SUBJECT: RIVER BEND STATION, UNIT 1 - AMENDMENT NO. 31 TO FACILITY  
OPERATING LICENSE NO. NPF-47 (TAC NO. 67878)

AMENDMENT TO FACILITY OPERATING LICENSE

Amendment No. 31  
License No. NPF-47

ATTACHMENT TO LICENSE AMENDMENT NO. 31

**FIGURE 3.2.1-1**  
**MAXIMUM AVERAGE PLANAR LINEAR HEAT GENERATION RATE (MAPLHGR)**  
**VERSUS AVERAGE PLANAR EXPOSURE BP8SRB094**

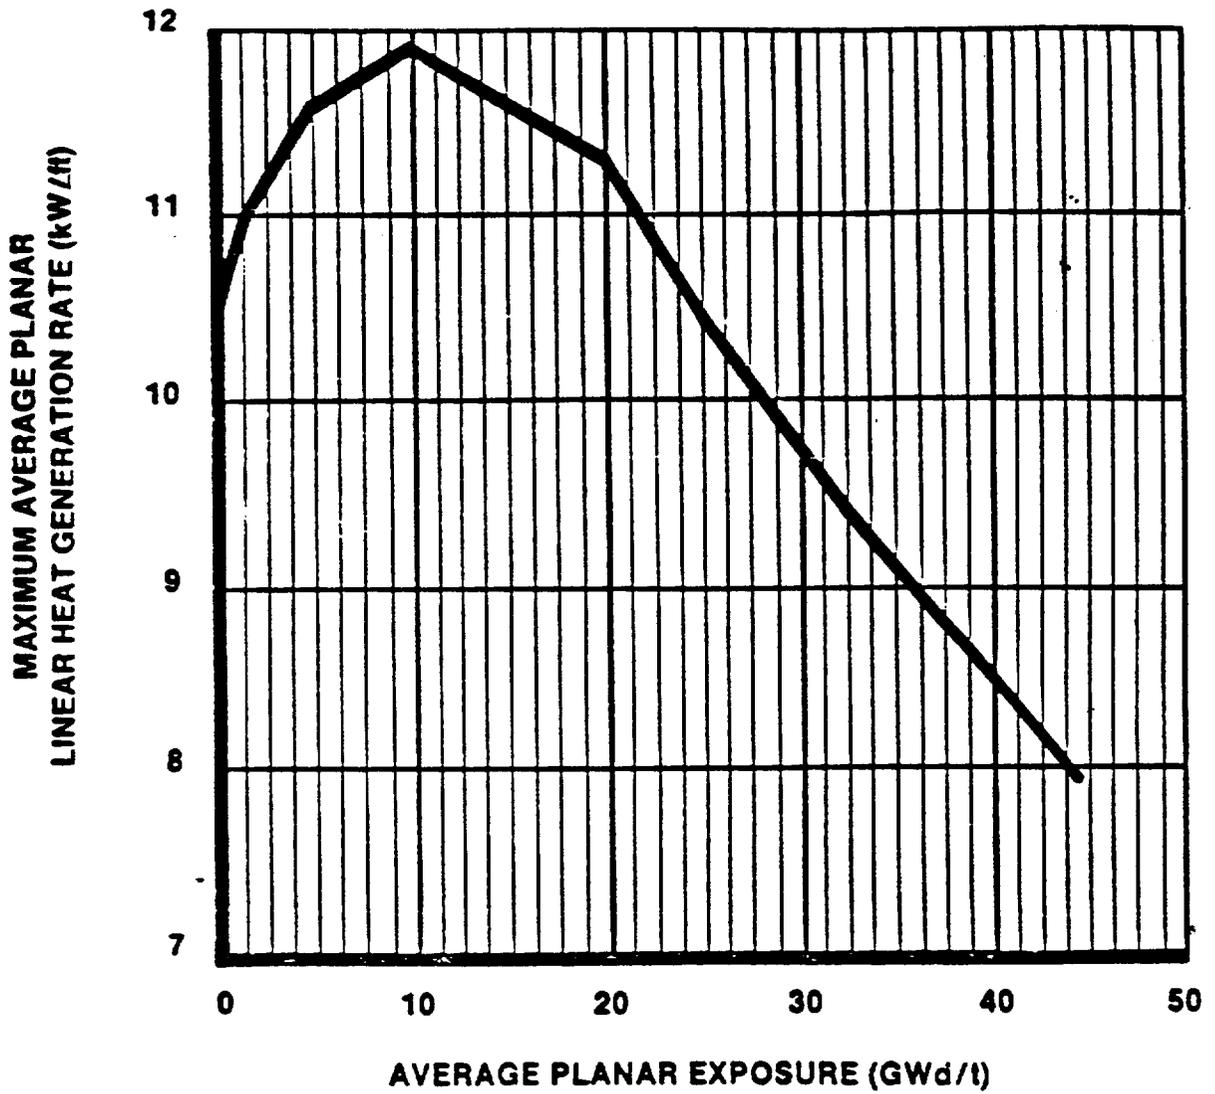
3.2.1 All AVERAGE PLANAR LINEAR HEAT GENERATION RATES (APLHGRs) for each type of fuel as a function of AVERAGE PLANAR EXPOSURE shall not exceed the limits shown in Figures 3.2.1-1, 3.2.1-2, 3.2.1-3, 3.2.1-4, 3.2.1-5, and 3.2.1-6. The limits of Figures 3.2.1-1, 3.2.1-2, 3.2.1-3, 3.2.1-4, 3.2.1-5 and 3.2.1-6 shall be reduced to a value of 0.84 times the two recirculation loop operation limit when in single loop operation.

For plant operation with a single recirculation loop, the MAPLHGR limits of figures 3.2.1-1 through 3.2.1-6 are multiplied by 0.84. The constant factor 0.84 is derived from LOCA analyses initiated from single recirculation loop operation to account for earlier boiling transition at the limiting fuel mode compared to the standard LOCA evaluations.

SAFE/REFLOOD calculations were performed for a full spectrum of large break sizes for the recirculation suction line breaks for the single-loop operation mode. The small differences in uncover time and reflood time for the limiting break size, i.e., 183 seconds for the single-loop vs. 184 seconds for the two-loop operation, would result in a small change in the calculated peak cladding temperature. The maximum average planar linear heat generation rate (MAPLHGR) reduction factor for the most limiting single-loop operation for PBX8R fuel is 0.84 which is conservative.

CORE FLOW (% RATED)  
 FIGURE 3.4.1.1-1  
 THERMAL POWER VERSUS CORE FLOW

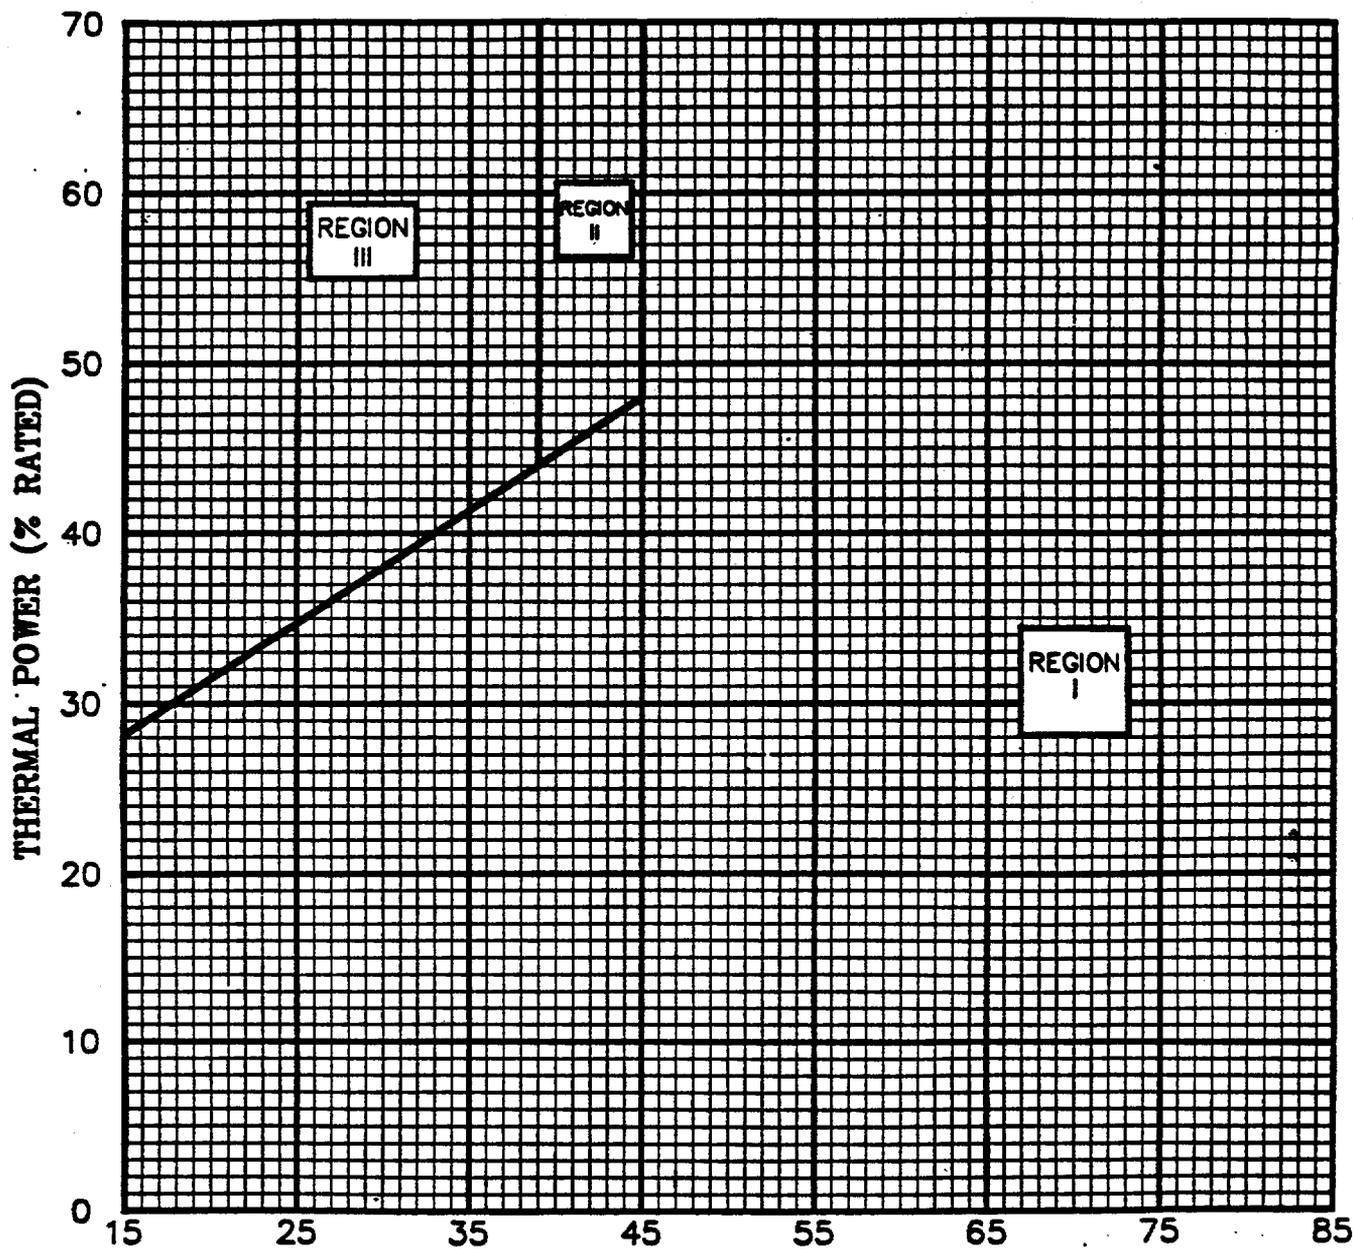
- g. With one or two reactor coolant system recirculation loops in operation and total core flow greater than 39% and less than 45% of rated core flow and THERMAL POWER greater than the limit specified in Region II of Figure 3.4.1.1-1:

- h. With one or two reactor coolant system recirculation loops in operation and total core flow less than 39% of rated core flow and THERMAL POWER greater than the limit specified in Region III of Figure 3.4.1.1-1, immediately within 15 minutes initiate corrective action to increase core flow to greater than or equal to 39% of rated core flow or reduce THERMAL POWER to less than the limit specified in Region III of Figure 3.4.1.1-1 within 4 hours.

The Technical Specifications related to the Recirculation Loops are modified to reflect single-loop operation considerations discussed in this Safety Evaluation. This includes replacement of Figure 3.4.1.1-1 to identify the detect and suppress regions of the power-flow map associated with thermal-hydraulic stability.
